PILATUS AIRCRAFT LTD. CH-6371 STANS, SWITZERLAND

## SERVICE BULLETIN

Service Bulletin No. PBA-34-001  
ATA Code 34

**SUBJECT:** Replacement of STC SA 00322DE 2<sup>nd</sup> Pitot Static System Pitot Heat Wires  
and Circuit Breaker.

Pre-SB PBA-34-001  
Figure 1

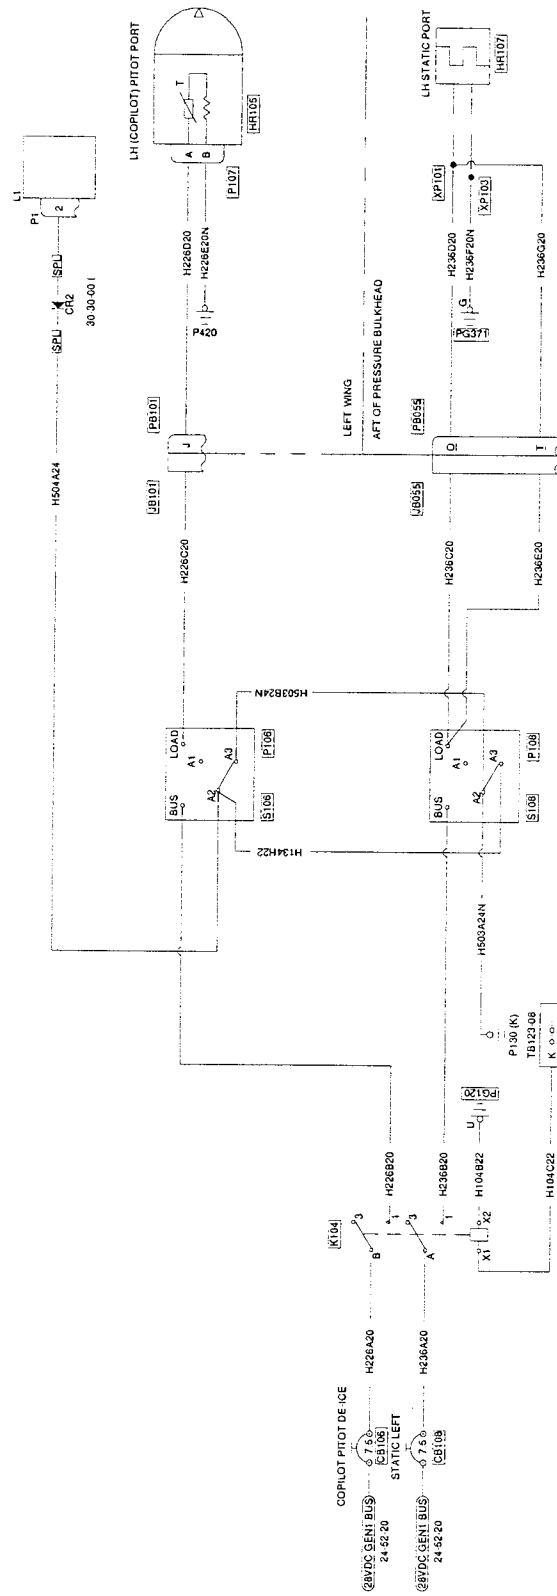
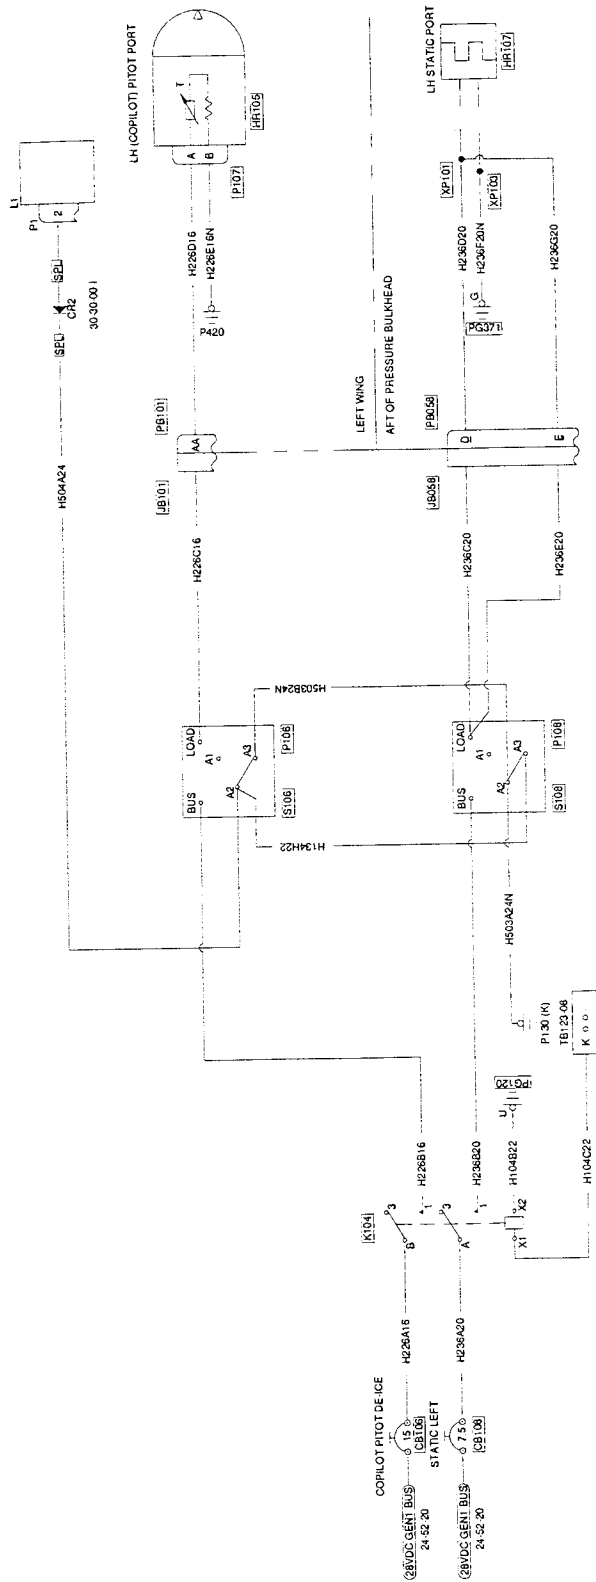
The 7.5 AMP circuit breaker and related wiring are incorrectly matched to the maximum potential, 15 AMP current draw of the pitot head.

Although incorrect, the system is considered safe because the circuit breaker is correctly rated to protect the installed, 20 AWG, electrical wires. Furthermore, the initial 'inrush' current is above the rating of the circuit breaker. Tests have shown that the current in the pitot head quickly stabilizes to a value below that of the circuit breaker rating. This also takes into account varying electrical resistances caused by changes in temperature at altitude.

Installation of minimum size AWG electrical cables.

- (1) Disconnect the cables from the applicable terminals (Ref. Fig. 1).
- (2) Remove the pins and connector lugs from the disconnected cables. Do not remove the cables from the cable looms.
- (3) Install a shrink cap on the cut ends of each disconnected cable.

Pilatus Business Aircraft Ltd. Service Bulletin No. PBA-34-001 requires the replacement of a 7.5 Amp circuit breaker with a 15 Amp circuit breaker and the replacement of 20 AWG wires with 16 AWG wires in the Secondary Pitot-heat circuit.

- (1) Disconnect and isolate the installed (20 AWG) cables.
- (2) Install cables of the correct specification (16 AWG)
- (3) Replace the 7.5 AMP (COPILOT PITOT DE-ICE) circuit breaker with a 15 AMP circuit breaker.

**C. Assemble and Install the New Cables (Ref. Fig. 2)**

Terminal (From)	End Connector	Cable	Terminal (To)	End Connector
CB106	Lug	H226A16	K104	Pin
K104	Pin	H226B16	P106/Bus	Lug
P106/Load	Lug	H226C16	JB101/J	Pin
PB101/J	Pin	H226D16	P107/A	Pin
P107/B	Pin	H226E16N	P420	Pin
